Planning Application Ref: BN/59/21/T

Location: 4 Appletree Drive, Barnham, PO22 0LJ

Description of works: Reduce height of 1no. oak (T1) by 6m and crown spread by 3m to leave a finished height of approximately 14m and a crown spread of approximately 6m

Comments on Application:

Figure 2 Positions of final cuts

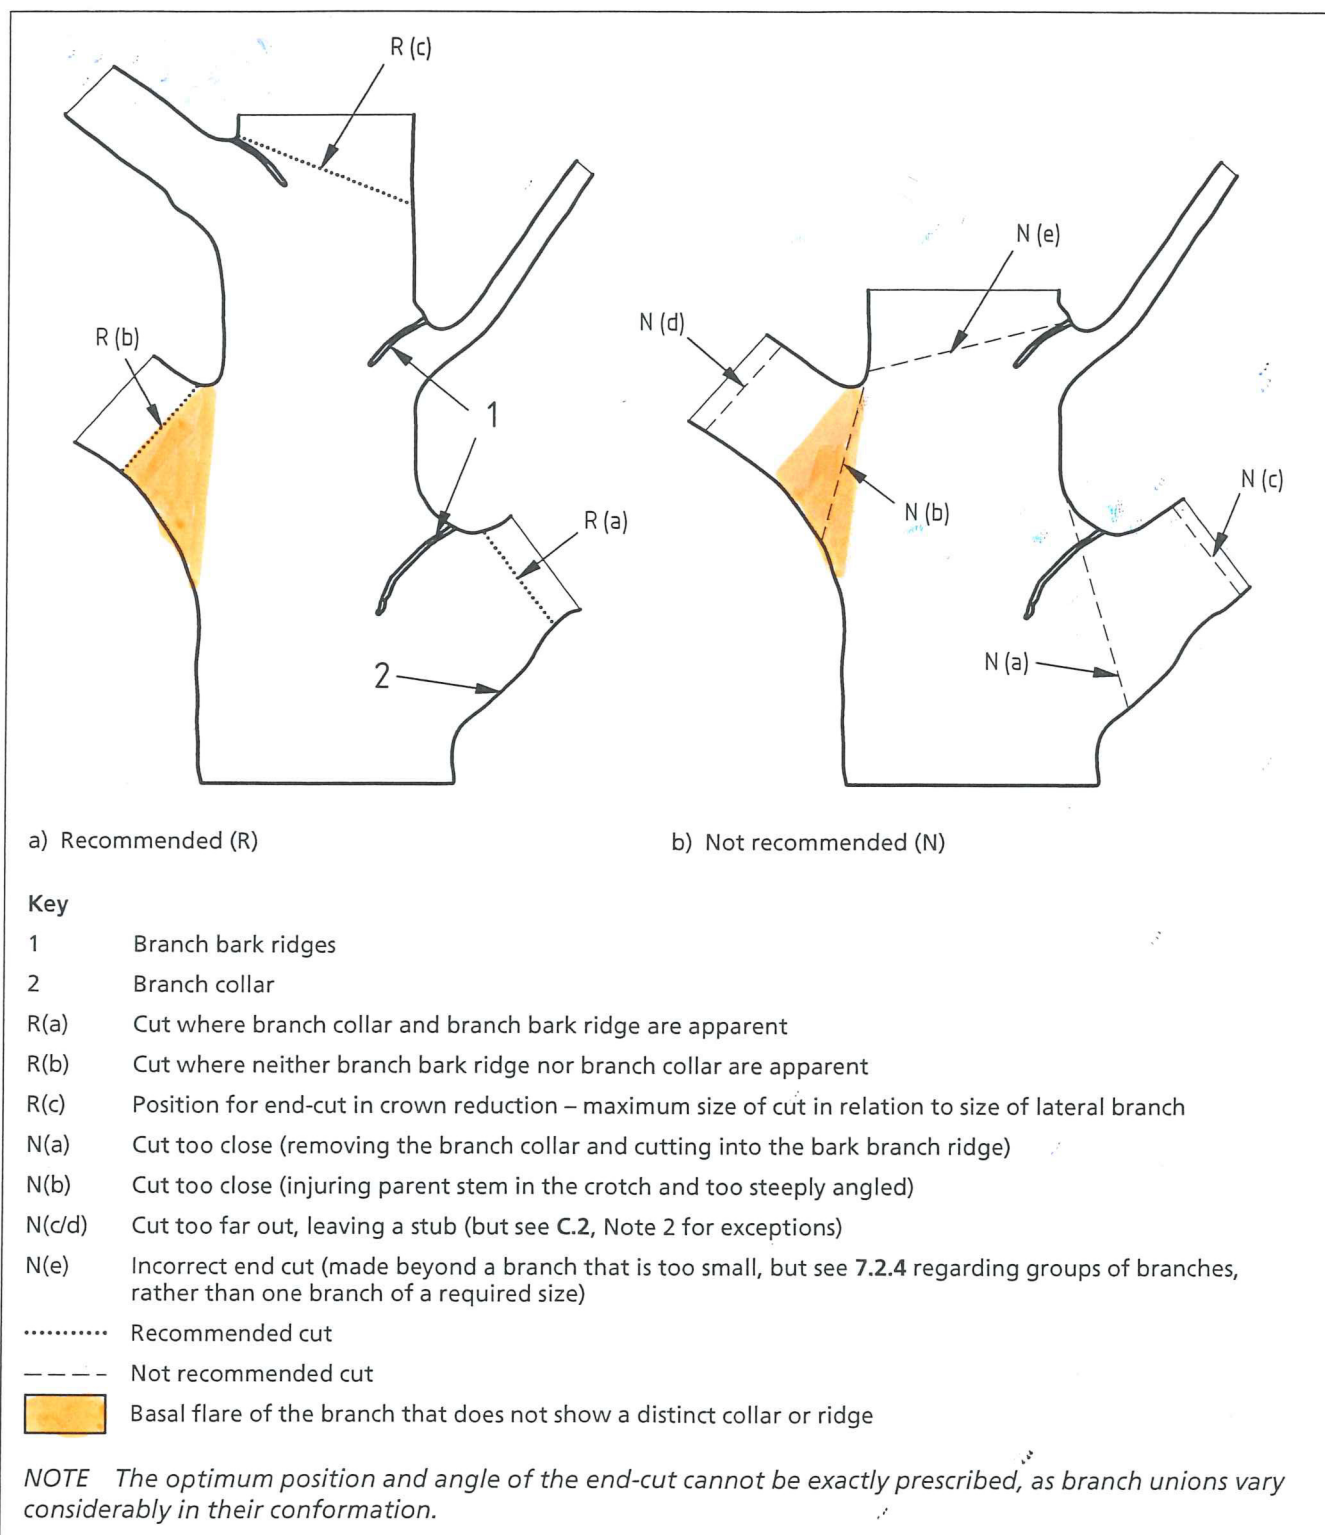
Part a) Where whole branches are to be removed and final cuts made close to the trunk or branch union they are to be made as shown in Figure 2 of BS3998:2010
